Clepa has investigated the industrial feasability of proposed GTR 7 Phase 2 dynamic proposed criteria. Proposed criteria and limits are :

Informal document GRSP-64-xx (64th GRSP 11-14 December 2018, agenda item xx)

2. Dynamic GTR7 phase 2 tests of GOOD EuroNcap seats by Clepa : Results :

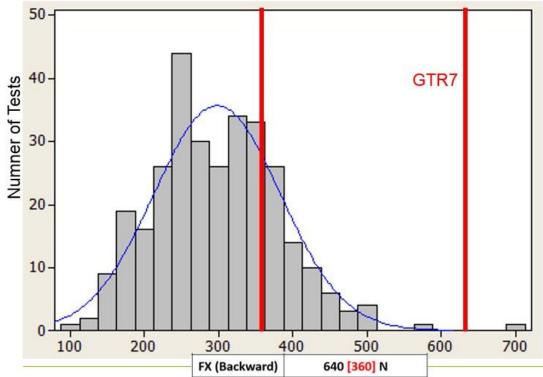
- 1 of 6 seats did not fulfill German proposal the seat not fulfilling german proposal was limit for GOOD EuroNcap rating
- 5 of the 6 seats would be too borderline to allow serial production in respect to german proposal

80 % of tested GOOD EuroNcap seats will not fulfill the requirements for industrial production and GTR7 phase 2 german proposed injury limits.

Summary R&R for NIC and calibration corridor :

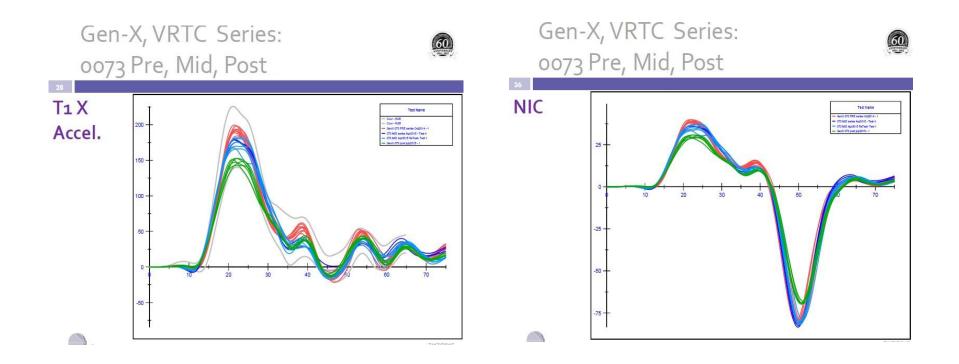
Humanetics : Repeatability : cv = 9.9% and +/- 2 sigma = +/- 7 m²/s² Reproducibility : cv = 10.7% and +/- 2 sigma = +/- 7.5 m²/s² Clepa : Repeatability : : cv = 13.6% and +/- 2 sigma = +/- 3.8 m²/s² Calibration corridor : none for NIC, but influence by T1 acceleration corridor:

Summary R&R for My+ upper and calibration corridor :

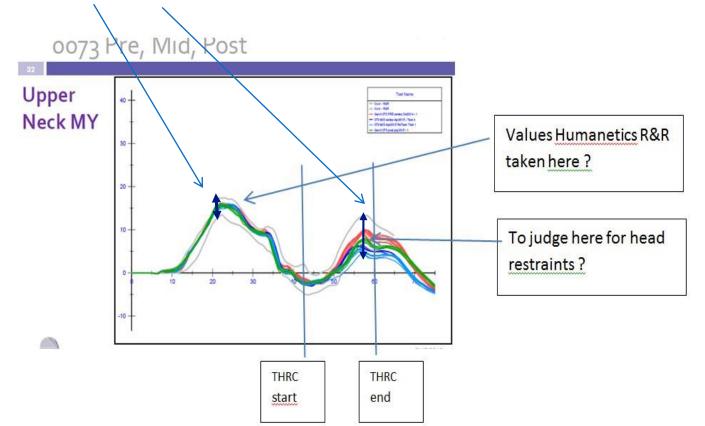
Humanetics : Repeatability : cv = 1,7% and +/-2 sigma = +/-0.6 Nm

Reproducibility : cv = 5,3% and +/-2 sigma = +/-1.6 Nm

Clepa : Repeatability : cv = 15,3% and +/-2 sigma = +/-3.8 Nm

Calibration corridor : here or here ?

Summary R&R for Fx+ lower and calibration corridor :

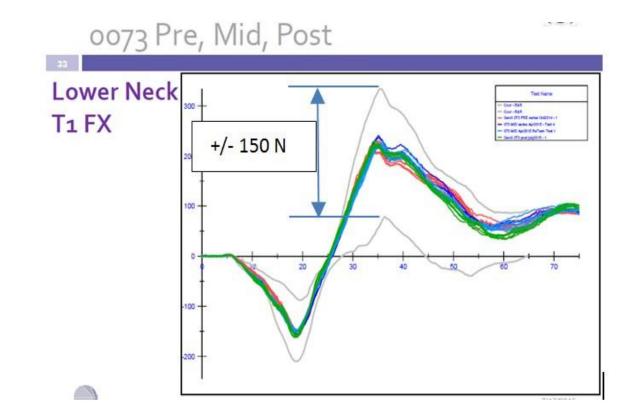
Humanetics : Repeatability : cv = 3,4% and +/-2 sigma = +/-15 N

Reproducibility : cv = 10.5% and +/- 2 sigma = +/- 47 N

Clepa : Repeatability : : cv = 10.7% and +/- 2 sigma = +/- 47 N Calibration corridor : +/- 150N
